# Technical Memo

Project Name: 401 Rochedale Road - Response to Flooding Issues

Our Reference: 20-0102TM-V2

## 1. Response to Information Request

FIGURE 3-4: INTERIM PEAK FLOOD LEVELS AT SOUTHERN BOUNDARY OF PINNACLE

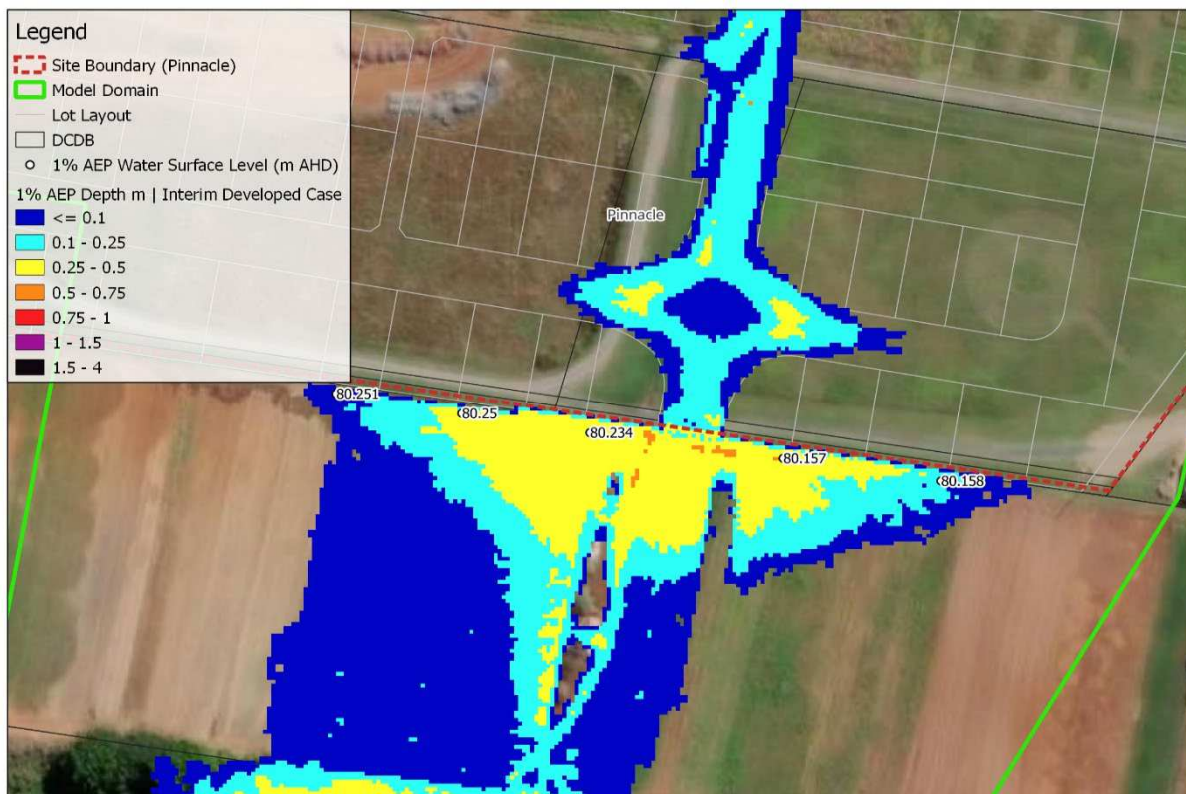
There is no flooding being shown on the property to the South of Pinnacle. While for [the] ultimate it's not an issue, in the interim scenario it is	The model has been modified to include inflows upstream of the southern boundary of Pinnacle. The modelling has determined a minimum fill level

because it may influence the flood immunity of lots along that Southern Boundary and the pit inlet needs to be modelled in the interim scenario.

over lots 146 to 149 and 150 (The Pinnacle at Arise Stage 8) to ensure immunity and is provided in Section 3.3.7.3. The pad levels of lots 146 – 149 of Pinnacle are to be raised above the predicted 1% AEP flood levels to maintain flood immunity.

Overland flow is to be directed toward the road, with minor flows (up to and including the 10% AEP event) to be collected by the pit inlet, with the difference of flows to be routed via kerb and channel north.

The TUFLOW model includes a custom inlet curve at this location which has a maximum capacity of 4.0392 cumecs above 0.3 m depth. Suitable inlet arrangements will be determined on detailed design.

### 3.3.7.3. Pinnacle Southern Boundary Lot Immunity
